**TO:** Lara Fiscalini (Statutory Planning)  
**FROM:** Amruta Pandhe, Christian Lundh (Urban Designer) and  
Blake Farmar-Bowers (Open Space)  
**DATE:** 18 May 2020  
**SUBJECT:** 1 Latrobe Avenue, Alphington  
**APPLICATION NO:** PLN19/0931  
**DESCRIPTION:** Construction of residential development in Precinct 5 (Workshop Precinct) of the Alphington Paper Mills development comprising dwellings and associated communal facilities, vehicle access, car parking, landscaping and a reduction in visitor car parking.

## COMMENTS SOUGHT

Comments are sought on drawings received on 1 April 2020.

*Proposed West Elevation*

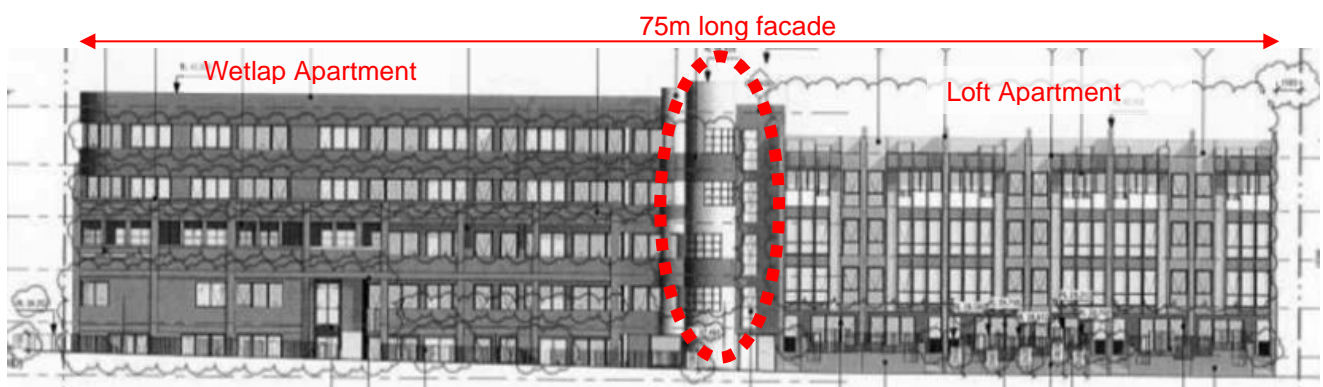
Clause 43.04 states that visually dominant buildings must be avoided through the use of discontinuous forms, well-articulated facades, and natural or recessive materials. The Loft Apartment is located immediately south of the Wetlap Apartment creating a 75m long facade along the Paper Trail frontage. To break this form the proposed design provides a variation in the material by using dark render finish (REN02) for the southern end of Wetlap Apartment. However, this does not avoid in creating a visually dominant continuous 'wall' of buildings. Hence, it is recommended to increase the setback of this section (shown in red below) to create a physical break in the built form. It is acknowledged that there are such long facades in other sections of this development but they are located along Chandler Highway and Heidelberg Road frontage and less along local streets/trails.

Proposed Ground Floor Plan (Wetlap section only)

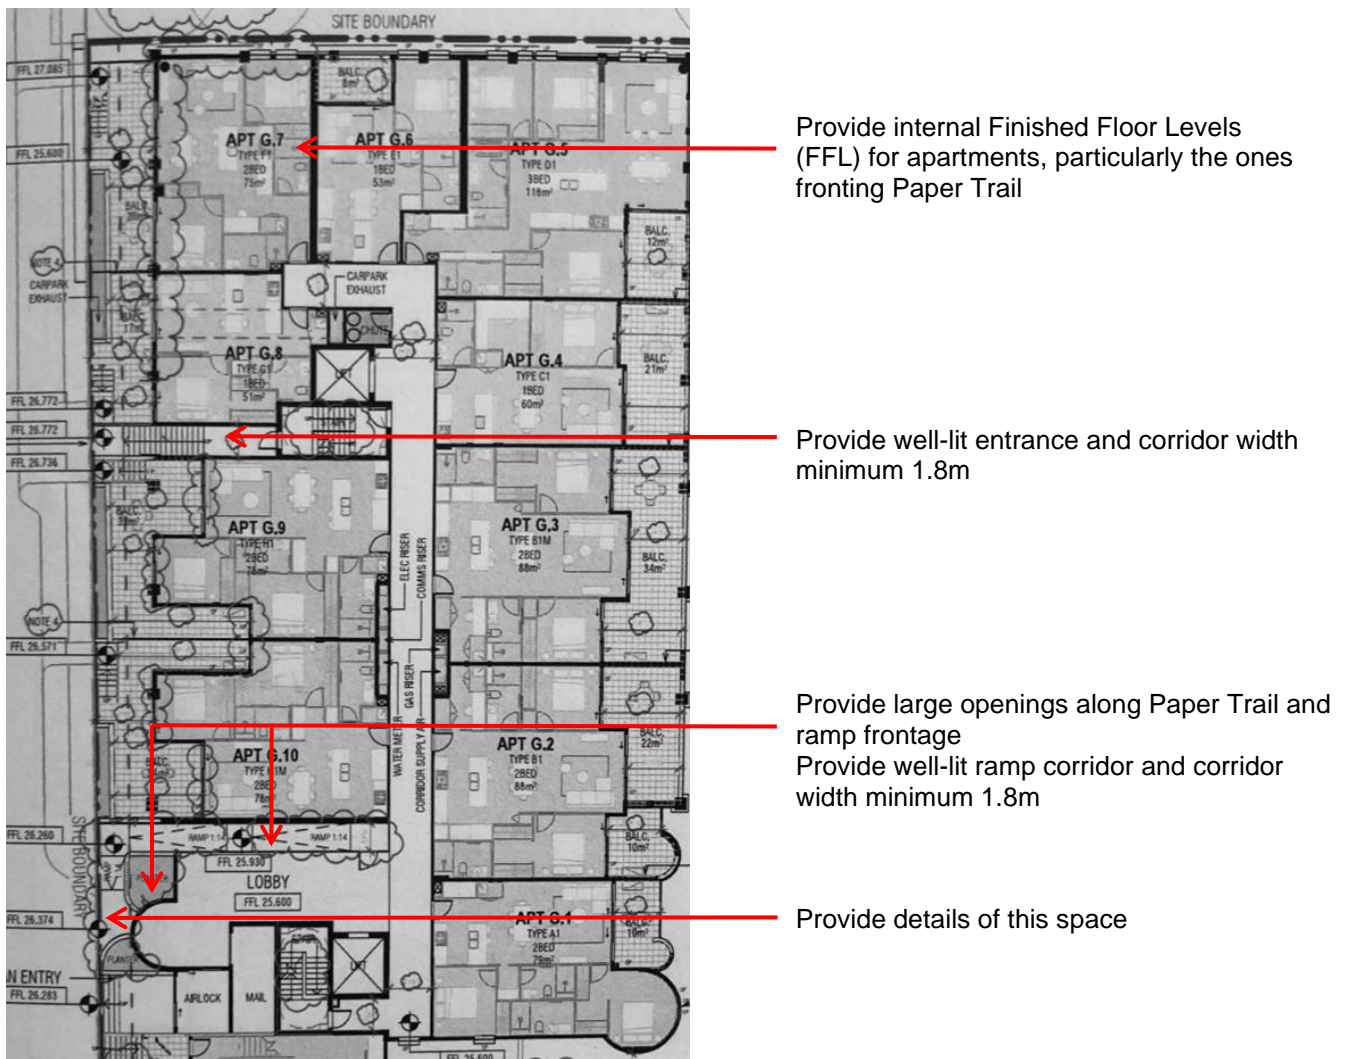
The secondary entrance to the apartments corridor provides metal frame around it to make it more eligible which is acceptable. The corridor for this secondary entrance is almost 9m deep and the ramp corridor next to main lobby is almost 15m deep. Both these areas must be well-lit all the time to enable safe pedestrian access and avoid creation of areas for hiding. As per Precinct Design Guidelines of the Development Plan the minimum corridor width should be 1.8m. Please provide the details of the wall between the lobby area and ramp. It is highly recommended that there are large openings in this wall to ensure passive surveillance to the ramp.

The use of vertical steel blade fencing allows for passive surveillance of the street. The overall height of fence is approximately 1m-1.1m which is supported.

*Proposed East Elevation (Wetlap Only)*

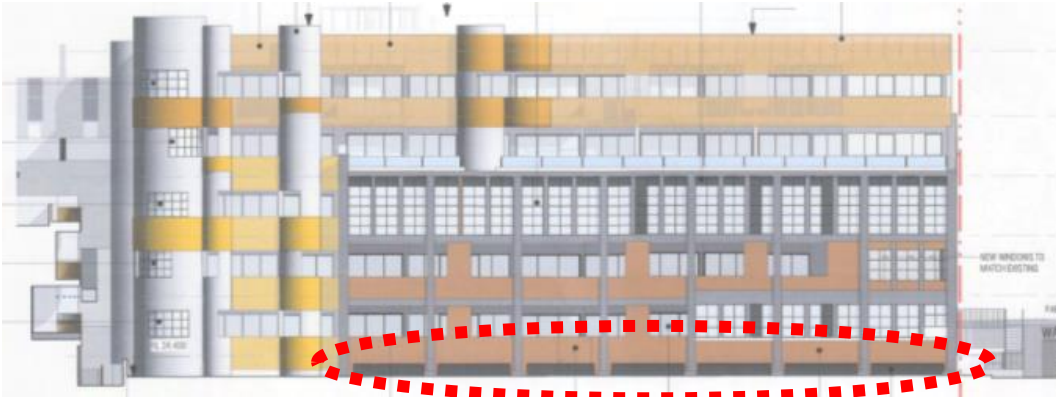
Paper Square Park frontage is dominated with large balcony frontages on all levels that will provide an engaging frontage and passive surveillance to the park. This is highly supported. The east elevation shows metal frame closer to the future natural ground level. The purpose of these metal frames is unclear as they are not part of the existing building. The basement / lower ground plan does not show any high level windows to the car park. Further, the render from UCR (pg 26) does not show these metal frames hence it is unclear whether there is an error in the elevation. It is requested to update the drawings to provide the right information.

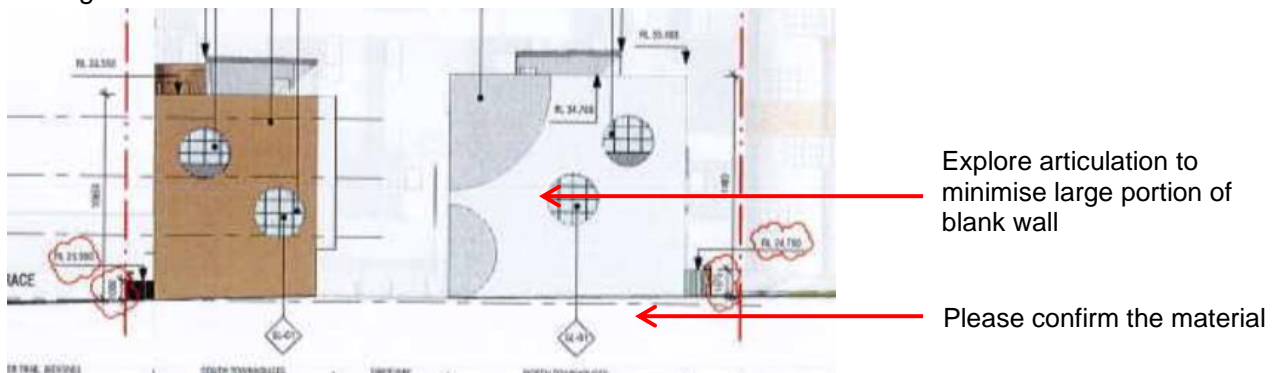
The use of vertical steel blade fencing allows for passive surveillance of the street. The use of recycled brick for fencing is highly supported. The finish floor level for ground level apartments is approximately 1.4m above the trail level. The overall height of fence ranges between 2.4-3m which is not supported. The precinct design guideline suggest maximum height of 1.2m, however, given the level difference it is recommended that the total fence height does not exceed beyond 2.6m.

#### Workshop Park Interface and Connectivity

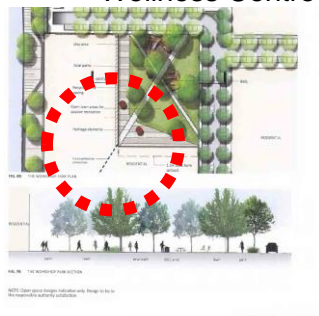
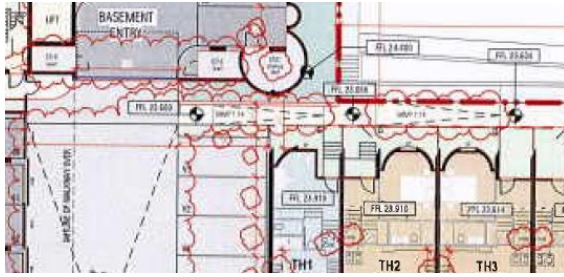
- Architecture and landscape architectural drawings are not aligned. A high quality and well resolved interface with Workshop Park and adjacent residential access and development is of priority.
- Confirm that this package has been co-ordinated with designers of Workshop Park. Ensure the design shown for the park is the most current to enable Council to undertake a complete review.

- Provide further details, sections and elevations showing relationship between the park and the proposed development.
- Outline grading and drainage approach along park interfaces. Annotate levels, falls and number of steps (including rise/run dimensions).
- Clarify what is shown on architectural drawings as highlighted below. This appears to show ramp, stairway and embankment configuration within the extents of Workshop Park. This arrangement is not shown within most recent park design.

- The Development Plan indicates an ambition to provide a cross axis link through the park and the proposed development, this appears to be lost with the ramp ending at the entrance of the car park.
  - MDG plans notes that the laneway will cater for the primary vehicle entry point to the car parks. Please clarify pedestrian movements and connectivity from the north east corner of the park through the development to Joels Terrace and the proposed Wellness Centre entrance.

- Ramp configuration is not supported, including but not limited to the following;
  - Base of ramp ends at car park entrance, at the base of the laneway crest.
  - Path is required to be made wider than the proposed 1200mm.
  - Yarra's Public Domain Manual notes-  
*A minimum of 1500mm wide for footpaths less than 3500mm where footpath width permits.*
  - Given this is primary pedestrian access to residential properties 1500mm minimum path width is required.
  - All required access to private developments needs to be incorporated within development title boundaries not with extents of Public Open Space.

- Confirm coordination between proposed surface material in the park and how this will relate to material along paths to the west and south side of the park.
- Confirm delineation between public and private land. There needs to be a clear distinction between public and private realm.
- Planting
  - Confirm how the private realm garden beds and private front gardens will complement and tie in with planting theme in the park.
  - Confirm the east side interface to Wetlap Apartment, how will these garden beds be maintained.

Paper Trail Interface

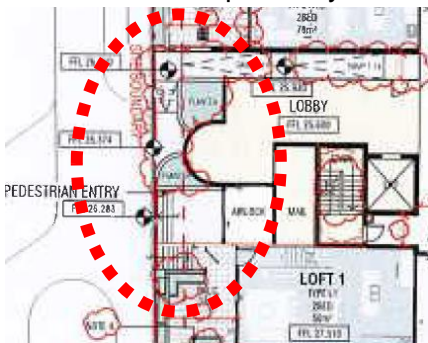
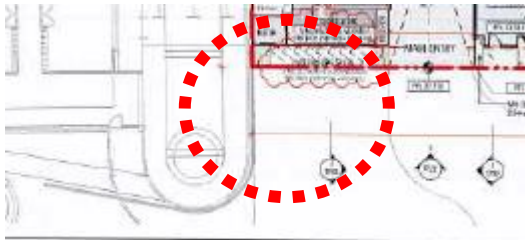
- Confirm levels and the relationship to the public realm along Paper Trail.
- Apartments fronting Paper Trail have planter boxes along the trail frontage. Are these at the same level as the Paper Trail or are these at lower level? How will the maintenance work? Also there is car parking underneath. Does that give enough depth?
- Landscape plan for this area is required, showing location and size of planter boxes and plant species and how these will complement the public realm along Paper Trail.
- Provide details of the landscaped area in front of the lobby, including floor level. Confirm purpose of the landing at the base of the ramp, can there be seating and bike parking located in closer proximity to the entrance?

- Can the ramp be better integrated for improve DDA accessibility?
- How will AC units (assumed to be located along terraces/balconies) be 'screened off' as these often bring down the visual appearance? How will planters be protected from AC exhaust that will blow hot/cold air and have detrimental effect on planting and the overall design vision of the development?

### Internal Laneway

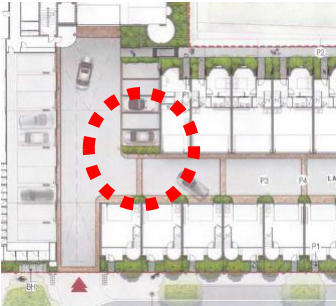
- Pedestrians can be assumed using the ramp from the Workshop Park and the laneway as a shortcut, clarify pedestrian movements in relation to car parks and swept paths.
- The greenery in the laneway is supported, interrogate opportunity to plant a large feature tree using strata cells, structural soils or similar in this space.

### Balcony Planters

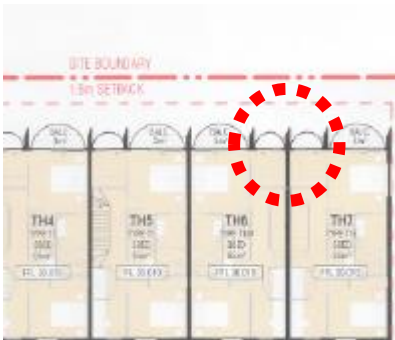
- Provide landscape plans showing all proposed balcony planter boxes.
- How will these be maintained to achieve the design vision?
- Add notes on all relevant landscape details to show size, depth, irrigation and nominated species.
